**Amendments to the Specification:**

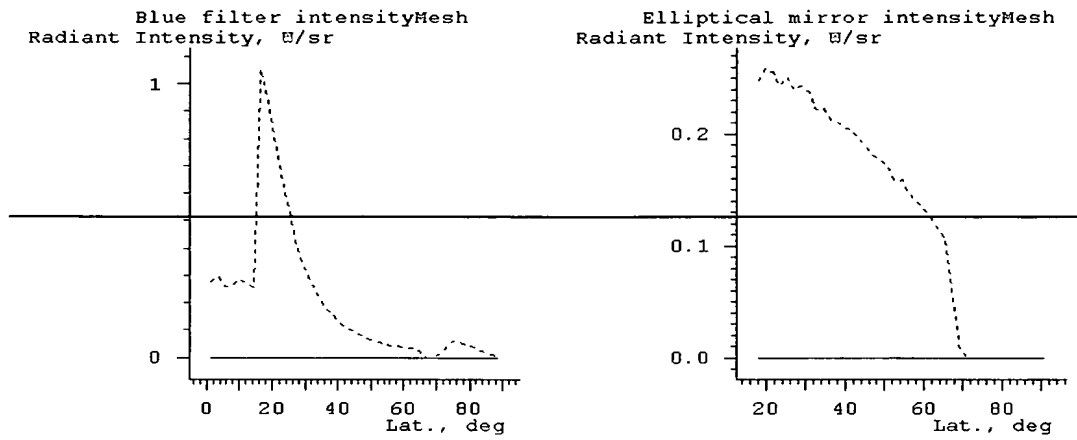
Please delete the two Tables shown in the paragraph beginning on  
page 7, line 1:

New Figures 5 and 6 have been added to replace Table 1 and Table 2 in the specification and are enclosed herewith. No new matter has been added.
